Bradley Heights Apartments

A 236-Unit Apartment Development Puyallup, Washington

Bradley Heights SS LLC

SITE PLAN 236 UNITS
1" = 40'

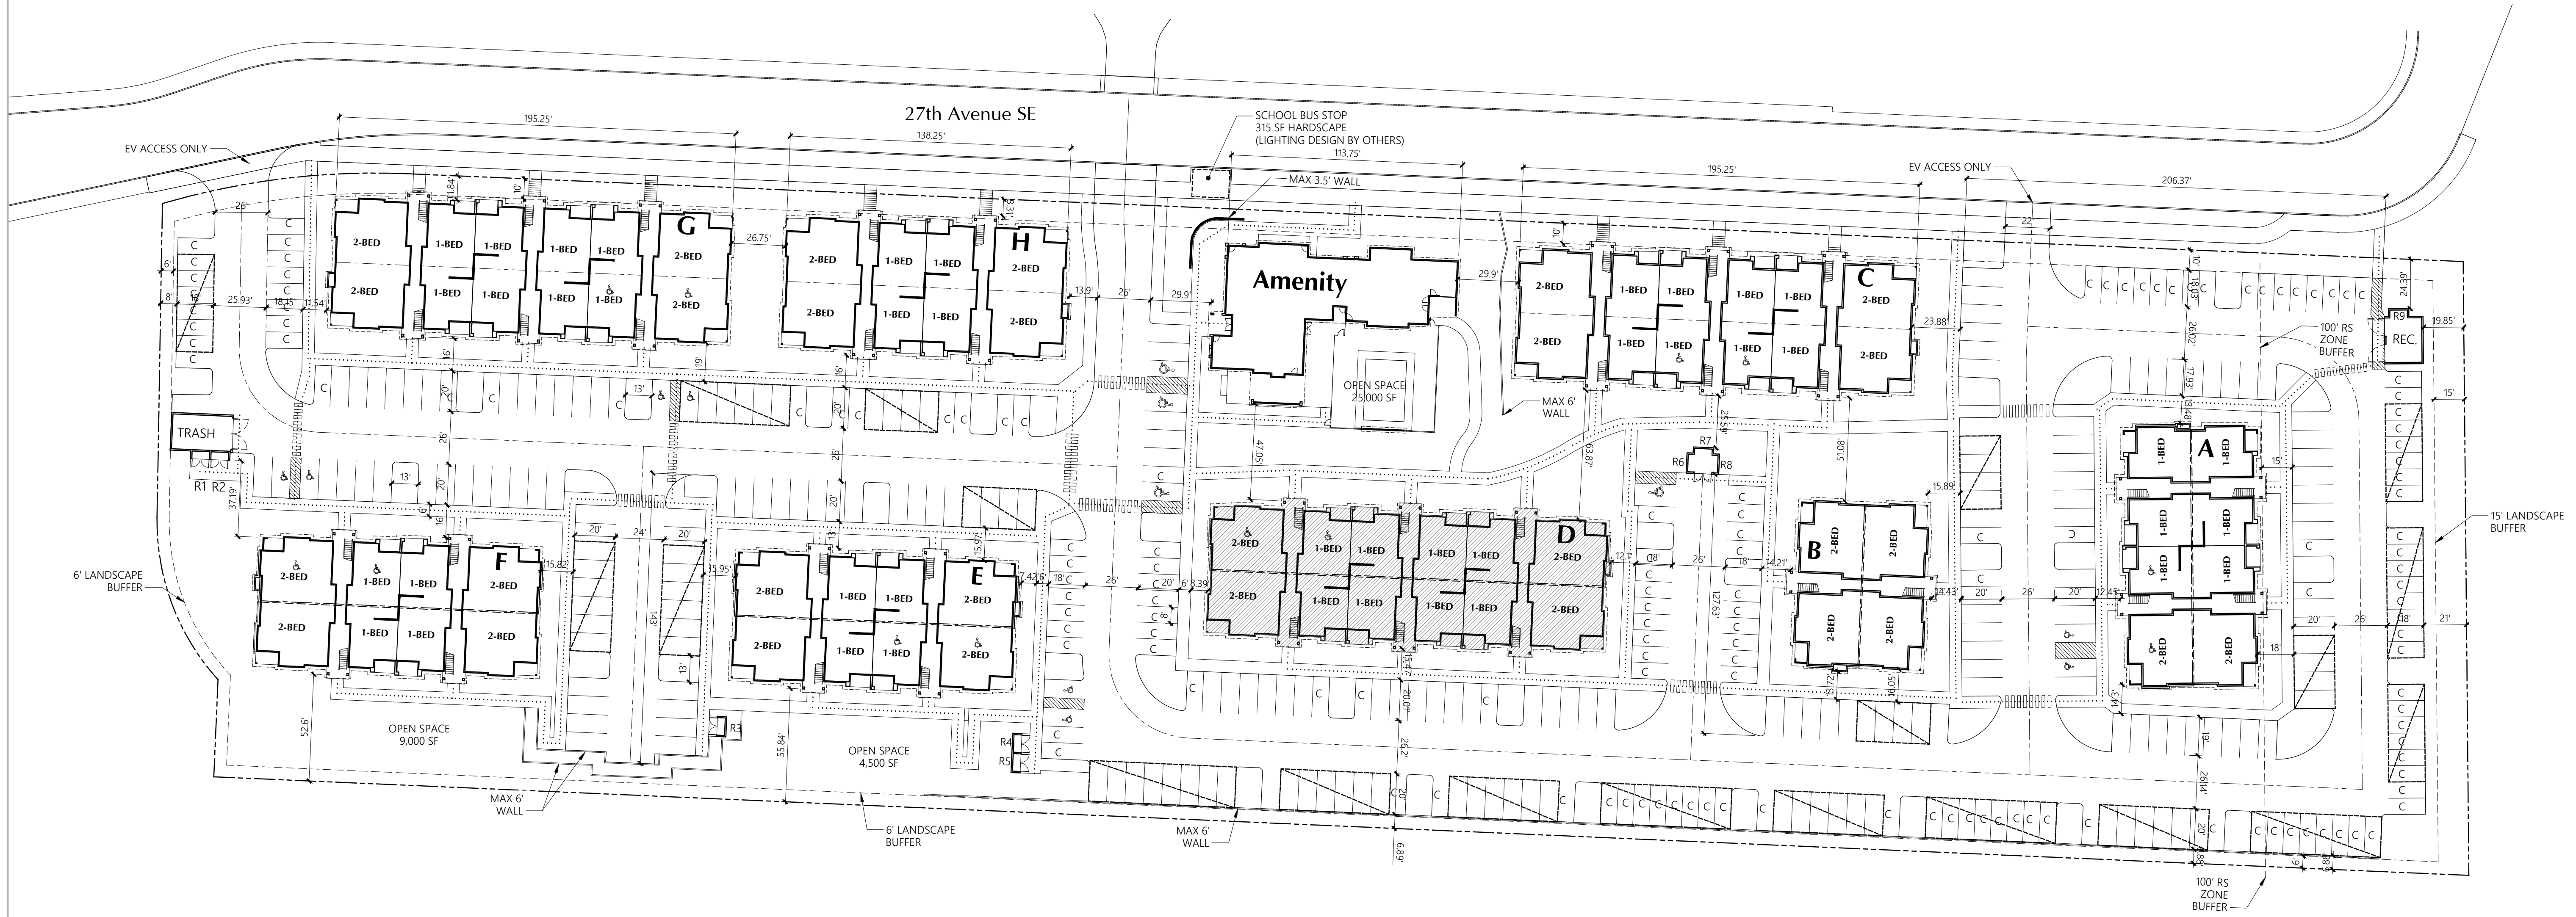
Provide egress plan with all dimensions with travel distance for all floors.
Page A2

BUILDING D
1st LEVEL PLAN
1/8" = 1'-0"
3/4 SPLIT LEVEL, 42-UNIT BUILDING

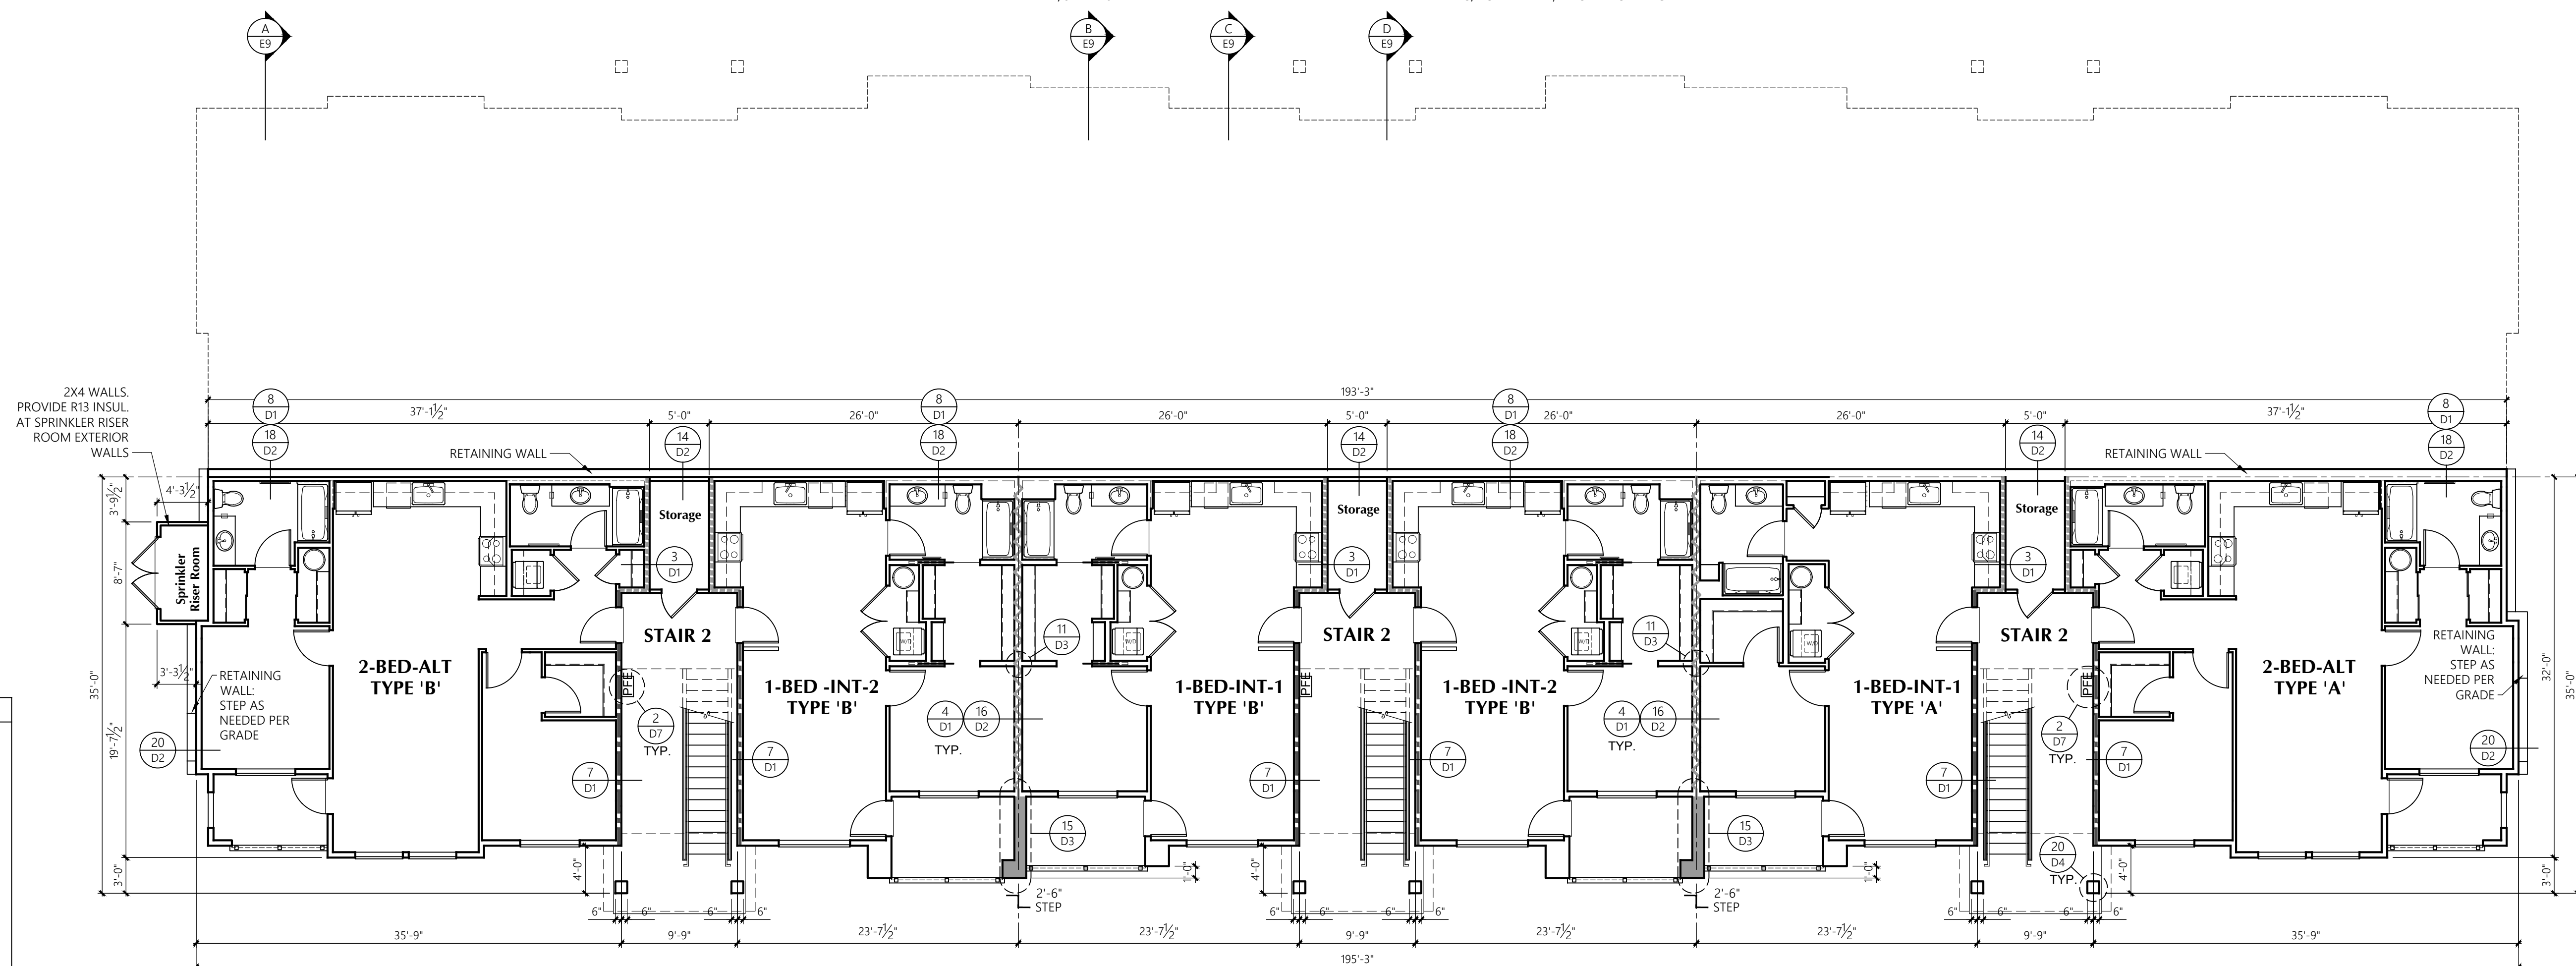
Provide fire stop detail for plumbing in 1-HR rated wall for all penetration in wall separating units. Wall section #6 unit separation wall does not reflect penetration in rated wall.
Page B5

BUILDING D
1st LEVEL PLAN
1/8" = 1'-0"
3/4 SPLIT LEVEL, 42-UNIT BUILDING

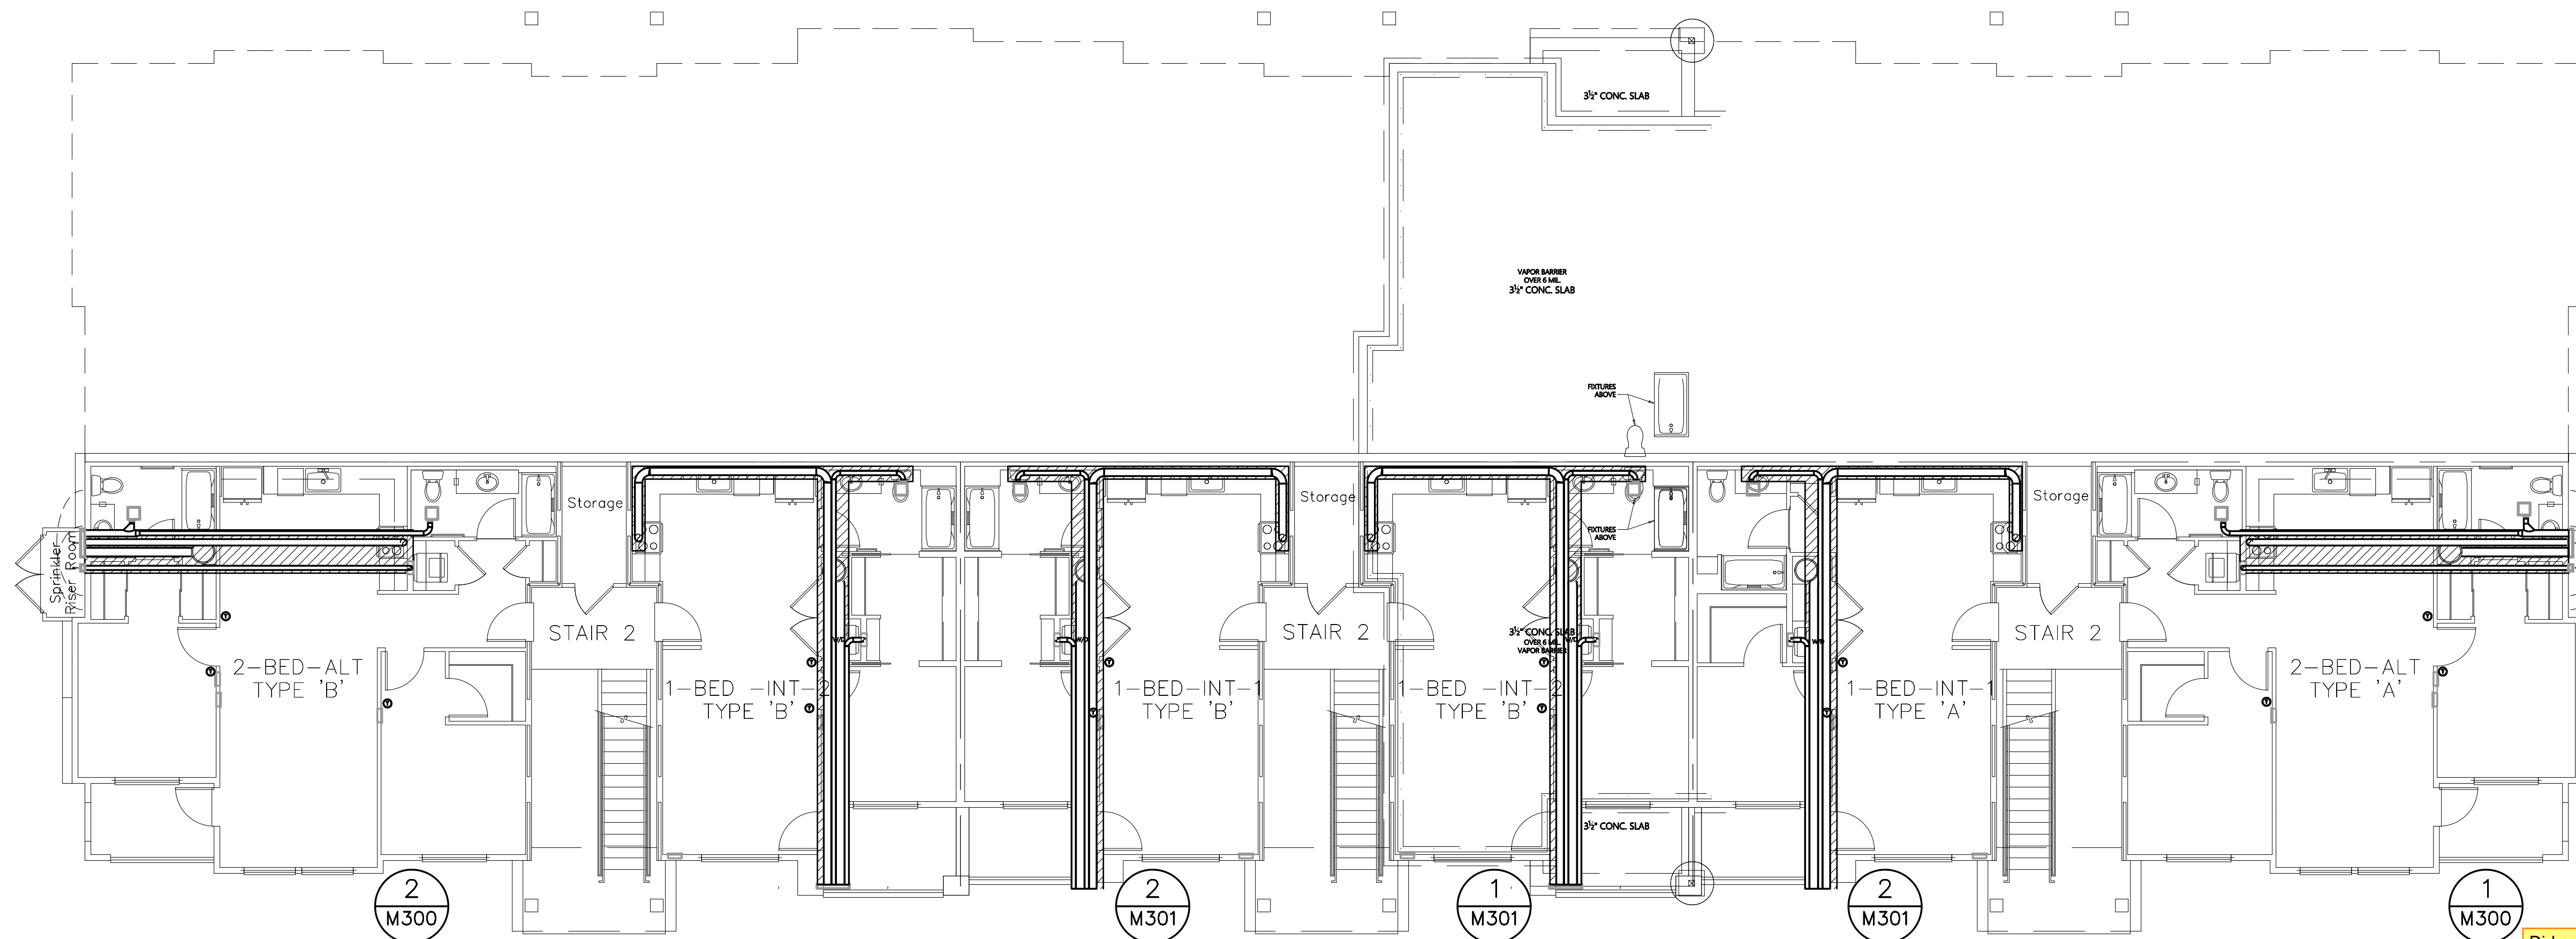
Provide lengths to all duct work for all floors to identify maximum duct length for all areas.
Page M2.0
